# Local Grant Identification for EPOC TDD (baseline proposal amendment)

Andrea Garavaglia and Patrick Stupar  
(Qualcomm)

# Gate processing in CLT for local (TDD) grant

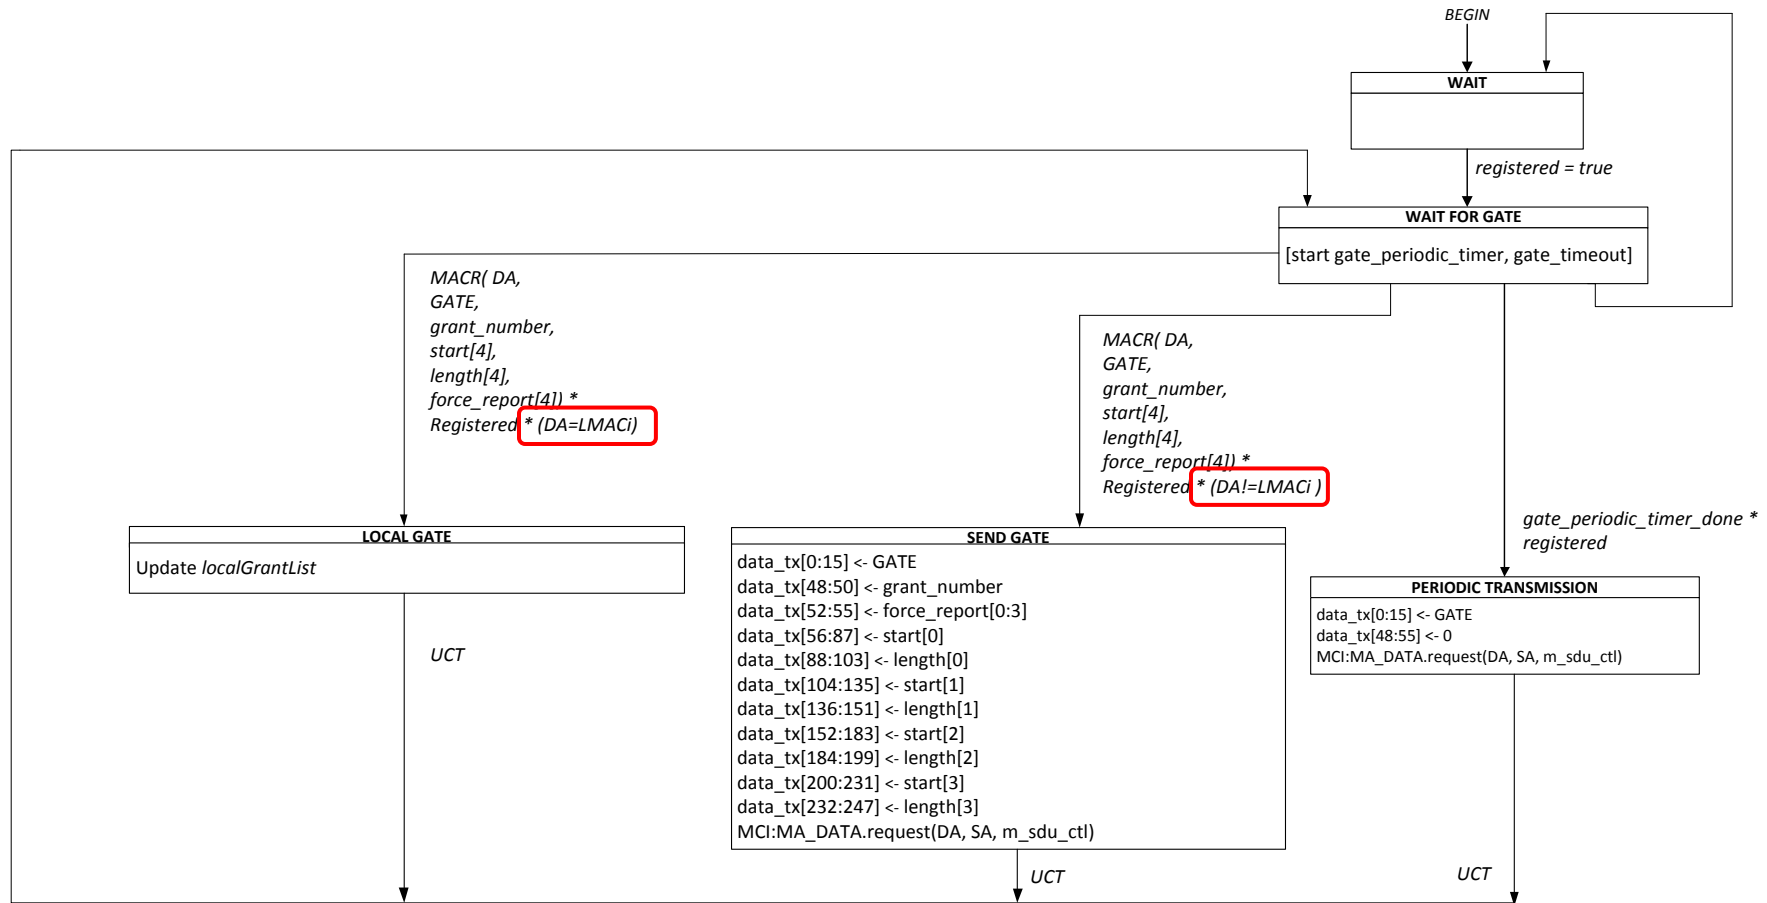
In the current design, the DA is used to identify a Local Grant from a CNU Grant (see red boxes above).

Comment: the Destination Address (DA) for non-discovery GATE in the *MA\_CONTROL.request* primitive is defined in IEEE 802.3 Clause 77.3.3.5 as “Multicast MAC Control address as defined in Annex 31B”.

# Comment Resolution proposals

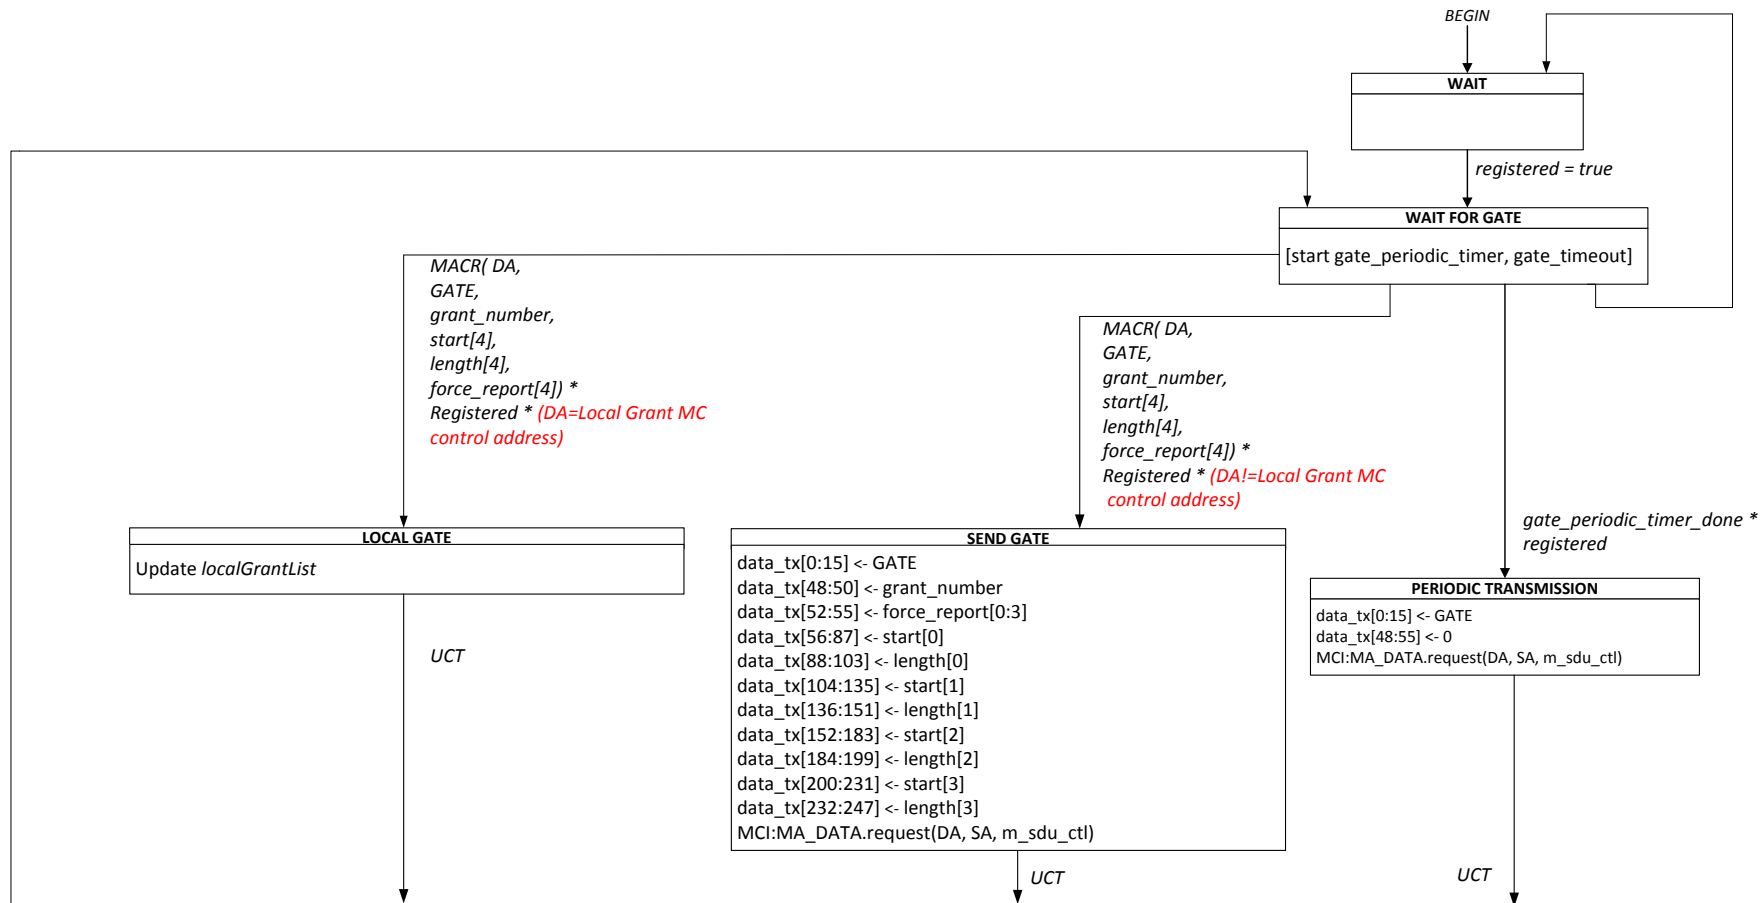
Two possible solutions are identified:

1. Definition of a new MAC control address for local grant
  - E.g. similar to the MAC control multicast address 01-80-C2-00-00-01.
2. Definition of a new primitive
  - Extend Gate *MA\_CONTROL.request* primitive for local grant gating

# Solution #1: required changes to TDD MPCP clause

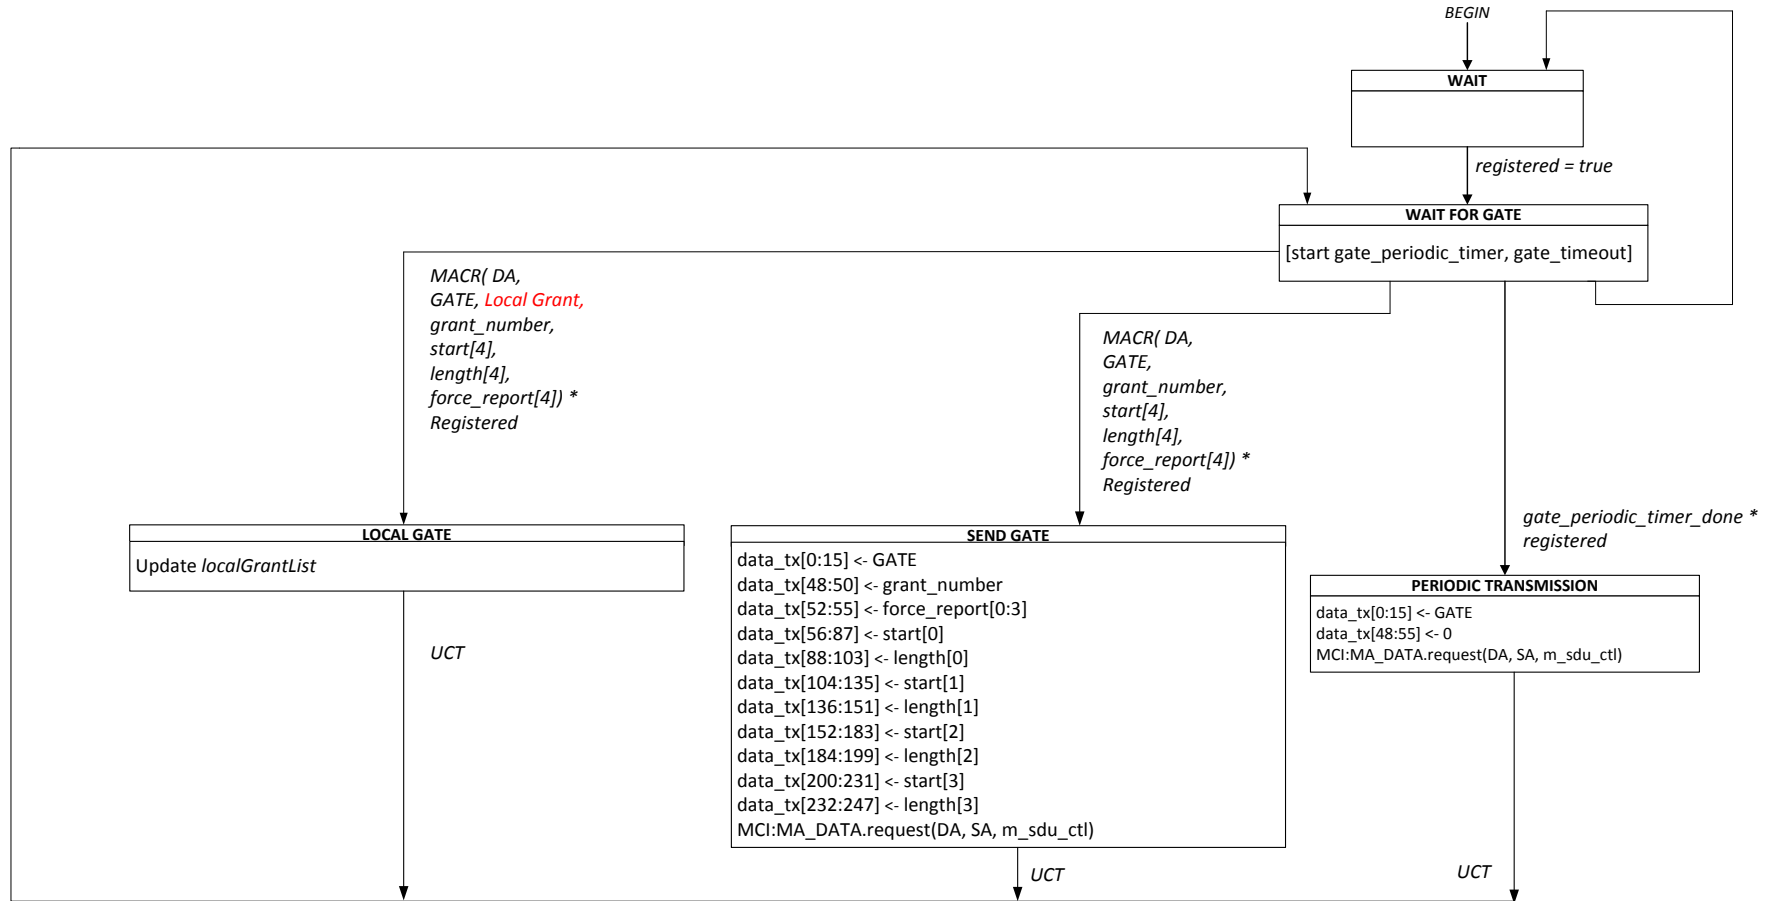
Definition of new MAC control multicast address ( e.g. 01-80-C2-00-00-02) and extension of the `MA_CONTROL.request` primitive

MA\_CONTROL.request (DA, GATE, grant\_number, start[4], length[4], force\_report[4]). This service primitive is used by the MAC Control client at the CLT to issue the GATE message to an CNU and to issue local grants for downstream transmission in TDD mode.

- DA: Multicast MAC Control address as defined in Annex 31B (if the primitive is used to issue the GATE message) or Multicast MAC Control address as defined in XX (if the primitive is used to issue the local grant GATE)
- GATE: Opcode for GATE MPCPDU as defined in Table 31A–1.
- grant\_number: Number of grants issued with this GATE message. The number of grants ranges from 0 to 4.
- start[4]: Start times of the individual grants. Only the first grant\_number elements of the array are used.
- length[4]: Lengths of the individual grants. Only the first grant\_number elements of the array are used.
- force\_report[4]: Flags indicating whether a REPORT message should be generated in the corresponding grant. Only the first grant\_number elements of the array are used.
